Access Compliance Report

Public Rights-of-Way

(Curb Ramps)

Intersection ID: 46783	Main Street: WINTER_VIEW_CT	Cross Street: DOMINION_VILLAGE_DR	Location: NW
ADA ID: 792A78096578	Ramp Type: PerpDiag	Initial Pass/Fail: Fail	Overall Compliance: No
Severity Score: 13.75			
Codes/Mitigation Info/Possible Solution		Field Measurements/Component Compliance

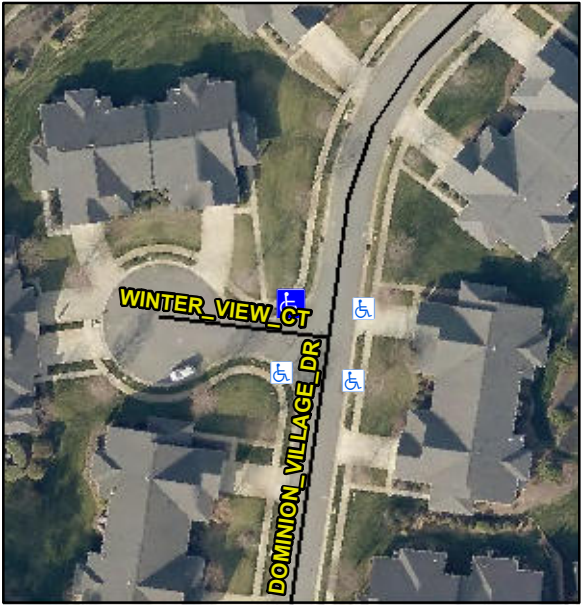
Possible Solutions:	Compliance	Description	Data	Compliance	Description	Data
	Remove & Replace Curb Ramp With Two New Directional Ramps or Equivalent.	N/A	Ramp Length (in)	48.0	No	Ramp Slope (%)	9.1
		Yes	Ramp Width (in)	48.0	No	Ramp XSlope (%)	3.7
		N/A	Flare Type LT	N/A	N/A	Flare Type RT	N/A
		N/A	Flare Slope LT (%)	N/A	N/A	Flare Slope RT (%)	N/A
		N/A	Flare Traversable LT?	N/A	N/A	Flare Traversable RT?	N/A
		N/A	Landing Length (in)	N/A	N/A	DWS Provided?	N/A
		N/A	Landing Width (in)	N/A	N/A	DWS Contrast?	N/A
		N/A	Landing Slope (%)	N/A	N/A	DWS Length (in)	N/A
		N/A	Landing X Slope (%)	N/A	N/A	DWS Full Width?	N/A
		N/A	Landing Curb? (Y/N)	N/A	N/A	DWS Offset (in)	N/A
		N/A	Shared Landing?	N/A			
		N/A	Gutter Ponding?	Yes	N/A	Gutter Slope (%)	N/A
		N/A	Gutter Lip Ht (in)	N/A	N/A	Gutter X Slope (%)	N/A
		N/A	Painted X Walk1?	No	N/A	Painted X Walk2?	No
			X Walk 1 Direction	To S		X Walk 2 Direction	To E
		N/A	X Walk 1 Width (in)	N/A	N/A	X Walk 2 Width (in)	N/A

X Walk 1 Slope (%)	5.1		X Walk 2 Slope (%)	0.8
			X Walk 1 X Slope (%)	0.2		X Walk 2 X Slope (%)	2.8
		N/A	Ramp inside XWalk1?	N/A	N/A	Ramp inside XWalk2?	N/A
<p>Surveyor Notes:</p> <p>N/A</p> <p>PROW/ADA:</p> <p>Not Found, R304.2.2, R304.5.3</p>			Road Slope (%)	1.9	N/A	Clear Space?	N/A
			Road X Slope (%)	3.6	N/A	Clear Space to XWalk (in)	N/A
<p>Total Cost:</p> <p>\$ 3200.00</p>		N/A	Any Obstructions?	N/A	N/A	Storm Grate/Utility Hazard?	N/A
			Obstruction Type			Storm Grate/Utility Type	
				N/A			N/A
				Yes		Surface Condition? (G/P)	Good
